Exhibit A-1

Proposed PD Amendment as recommended by Staff

Resolution Z-99-48, University Towne Center PD Conditions:

Petition Number
PB-14 21 PDA

University Towne Center PD Special PD Directional Sign Locations

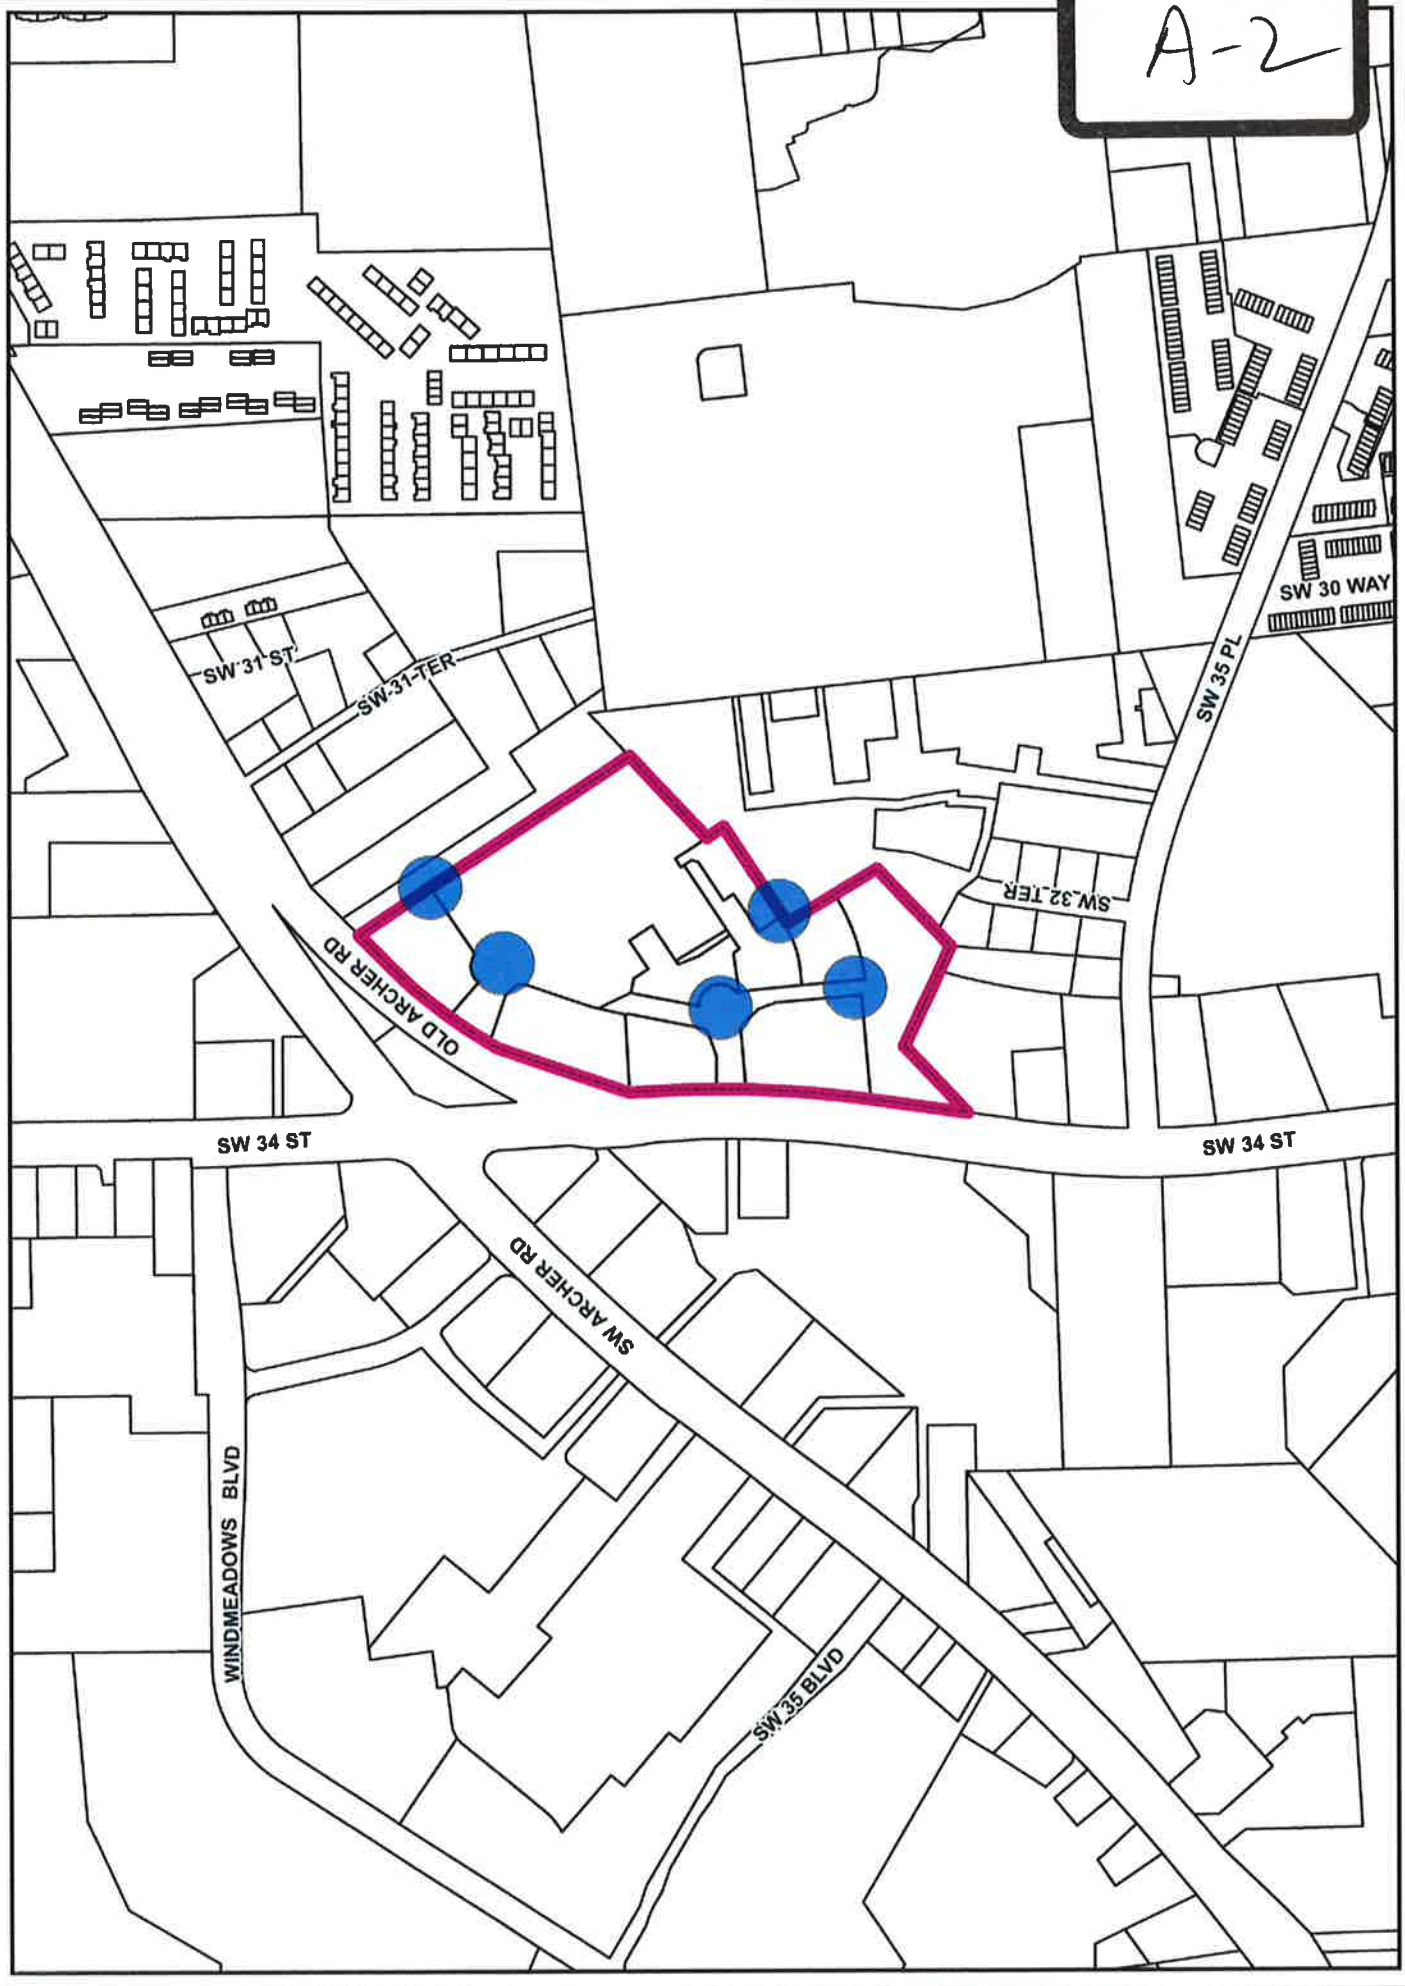
- h. Special PD Directional Signs: These signs shall be limited to the name of the development and/or the names of the occupants of the development, and shall comply with the following conditions:

- i. The signs shall not be located within 100 feet of any public right-of-way line.
 - ii. A single business or activity shall be limited to two (2) square feet per individual sign face.

- iii. The directional sign shall not exceed a total area of 50 square feet.
 - iv. The maximum height of a directional sign shall not exceed six (6) feet.

- v. A maximum of five (5) directional signs internal to the development is allowed in the PD and these signs may be sited only at the locations identified on the map entitled University Towne Center PD – Special PD Directional Signs.
